**ALTERATION TO A HISTORIC PROPERTY STAFF REPORT**

Site: 178 Central Street c.1840 Adams-Locke House  
Case: HPC 2014.014 Single Building Local Historic District

Date of Application: March 18, 2014  
Legal Notice: *Replace door and windows on kitchen ell.*  
Staff Recommendation: Certificate of Appropriateness  
Date of Public Hearing: April 15, 2014

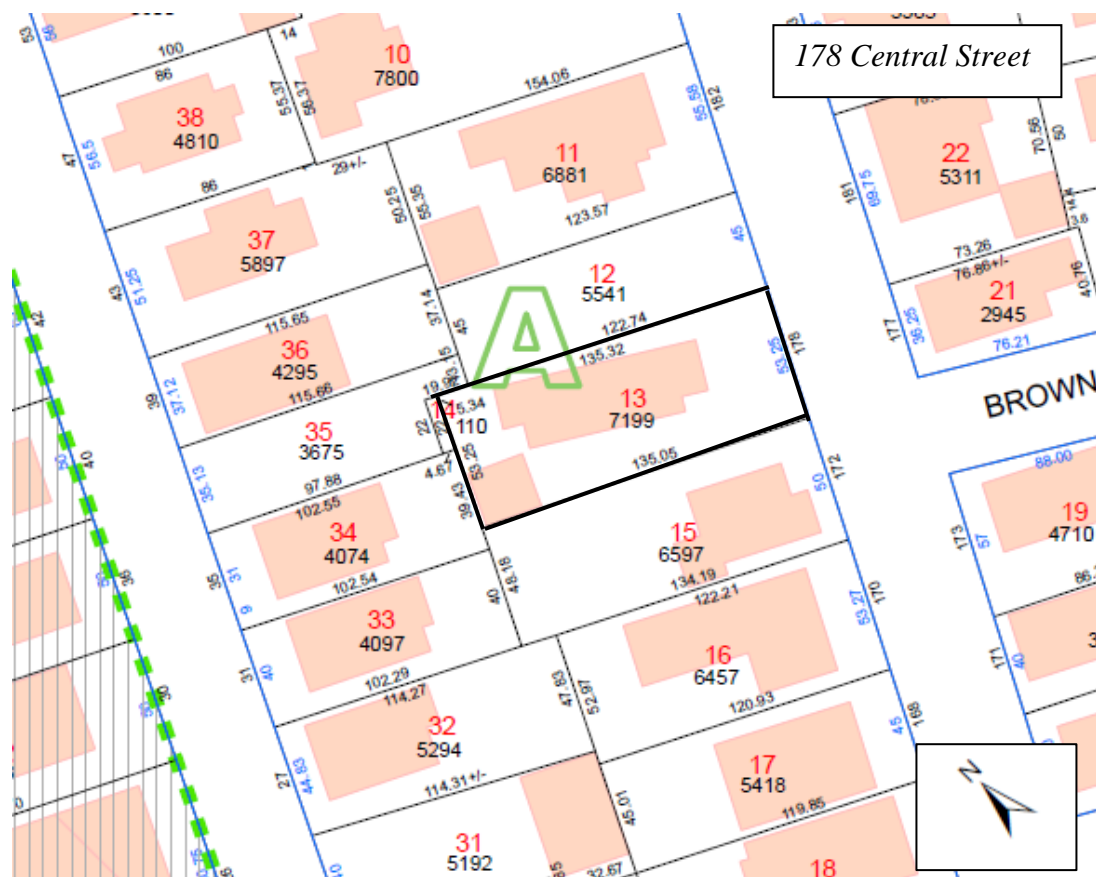
The Applicant finds the windows to be both beyond repair and improperly installed, therefore he proposes to install insulated 6/6 wood replacement sash with no Lo-E coating to replace the existing traditional 6/6 double-hung ones. The existing casings will be retained or replicated.

The new door on the rear will replace a later non-original solid wood door with one with divided lights to match the side door off the driveway. (See attached plan sketch and elevations.)
